Meeting: Planning and Development Committee **Agenda Item:**

Date: 29 November 2023

Application No:	22/00781/RMM
Location:	Land to the North of Stevenage, off North Road and Weston Road, Stevenage.
Proposal:	Reserved matters application for the construction of a Country Park including access, layout and landscaping pursuant to Outline permission 17/00862/OPM.

6.2.19 An east west cycle route

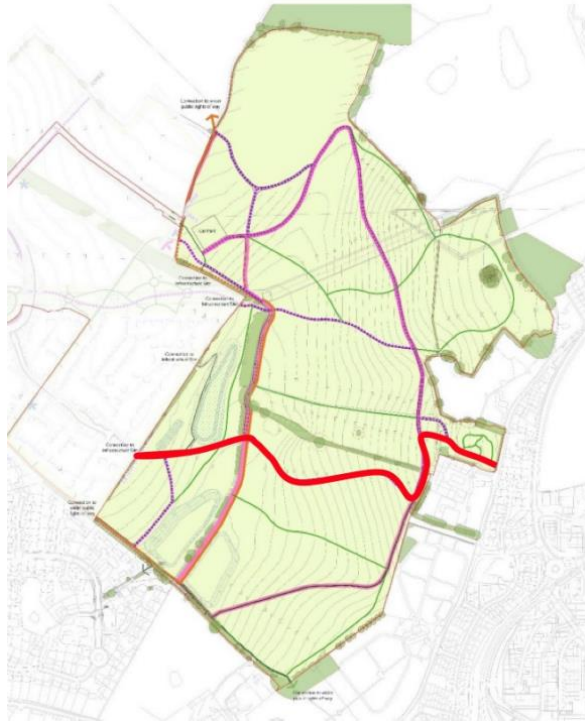
By the developers own admission, the appropriate width for an accessible path is 1.8 meters. Made from crushed gravel. This is what is in place at Great Ashby Park. Except for the east-west cycle route, and the existing bridle way, there is no need for any path to be wider than 1.8 meters and so, in our view, this should become the default width. Extract from developer's proposal –

There are three potential east west cycle routes 1) The first is to use just part of the path already proposed by the developer as shown in Red below

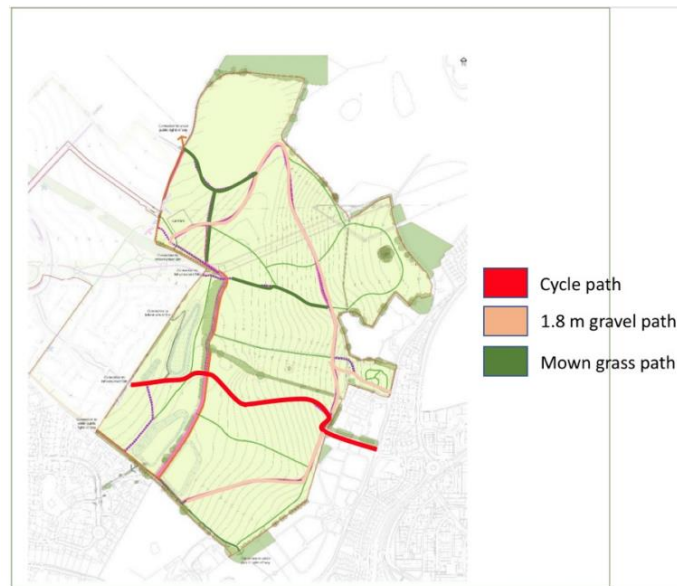
6.2.21 3) The final alternative would be for the cycle path to use the existing access to Weston Road via the cemetery.

6.2.22 Either which way, with a more tightly defined cycle path, all other new paths in the meadow could then be 1.8 meters in width and made from simple compacted gravel (like they are in Great Ashby Park) We believe there is also scope, to reduce the overall number of hard paths as shown below.

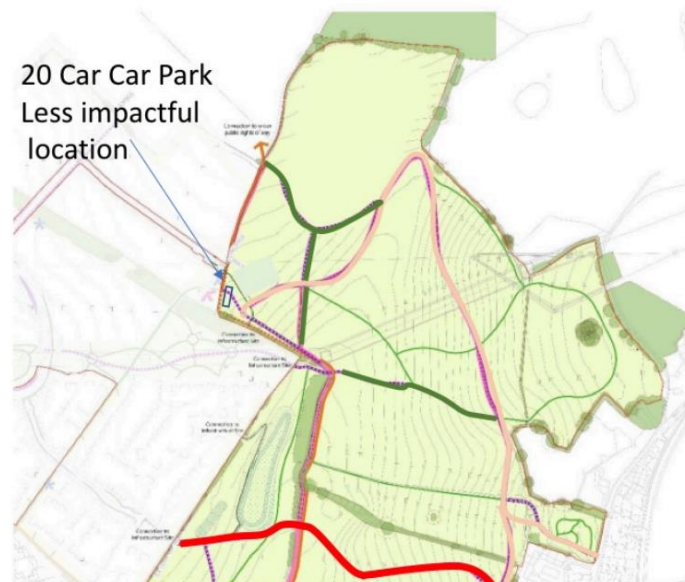
- 6.2.24 A new multi-use car park adjacent to St Nicholas Church This proposal has come forward with the full support of St Nics Church. Indeed, the Church is in advanced conversations with the landowner to purchase the land in question and use their own resources to convert it into a car park. This would see additional car parking being made available to visitors of the meadows in a period similar to that being brought forward by Bellway Miller for their car park. The land is in the ownership of the same land-owner Bellway Miller has purchased the meadows from. Indeed, over a year ago, Bellway Miller promised a meeting of FOFC, officers of the Council and the relevant Cabinet Member (Cllr Speller) that they would approach the landowner to see whether they could incorporate the land into their proposal. A year on and they have not followed through on that promise, they have not contacted the landowner and no progress has been made.

- 6.2.25 The new car park could be used by visitors to the church, cemetery, and meadows. It would draw visitors to the heart to Forster country. It could also be used as overspill for major church events and by parents at school pick up time. We strongly urge the Committee to reject the car park idea, until this option has been carefully considered by the developer and the Council.

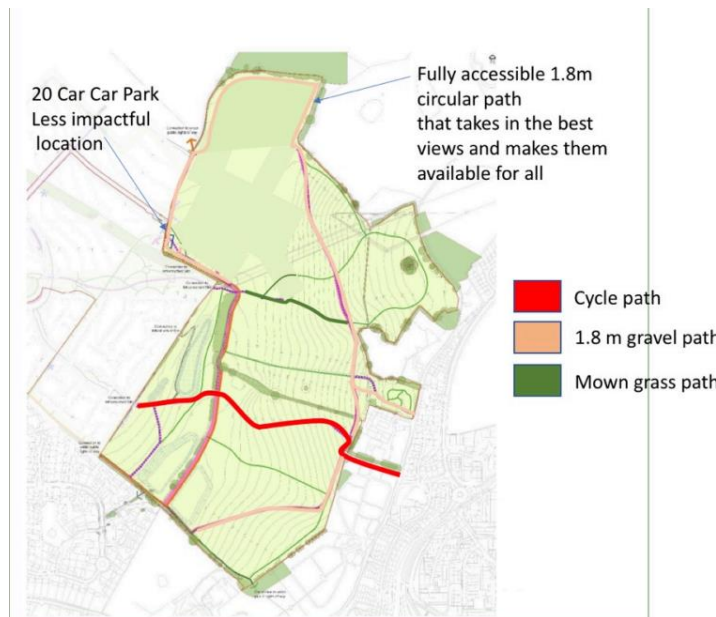
6.2.28 Creation of a 'landscaped mound" made from spoil from the construction site in the north-west part of the conservation area We provided a detailed objection to this proposal when it first appeared. Please see our original objection attached. We find it deeply disappointing that Bellway Miller are persisting with this outrageous proposal. If agreed, the dumping of spoil, will, forever alter the topography of the landscape as it would have been known to EM Forster. It causes unnecessary harm to an area that is already beautifully contoured and one of the most attractive parts of the conservation area for no apparent benefit other than it makes lighter work for the developer and saves them money.

6.2.29 An alternative proposal - By rejecting the mound, the planning committee can open the prospect of the northern part of the meadows to becoming publicly accessible. The views from the northern part of the meadows are stunning. Routing paths this way would also ensure maximum use of the paths/bridle way that are already there rather than putting more development on the fields. This would reduce the need for the multiple paths around the car park, and the additional developed paths criss-crossing the open fields. What a shame Bellway Miller chose not to consult us and instead put forward their plans using only a desk top exercise. We have known these fields for decades and know the best bits. On this basis, an alternative is proposed below. We invite the planning committee to agree this alternative proposal and reject the mound.

6.2.30 As shown above we propose looping what we would like to see as the 1.8m gravel path up to the north of the fields rather than cutting across them, before linking into the existing bridle way.

West-East PROFILE

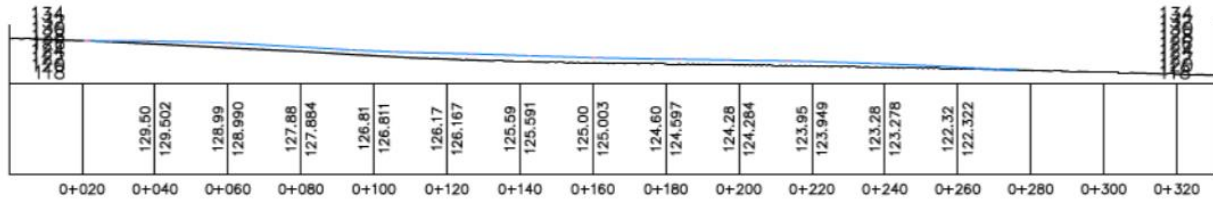
- 8.3.7 The field is of a significant size and would allow for the soil to be spread across a large area and following the contours and grading of the existing slopes, such that it would blend in. It would not be a prominent heap of soil or a typical 'mound' form. The below profiles taken from the TN represent the changes in a good visual form, showing the grading change and not the 'mound' shape perceived following previous use of this noun.
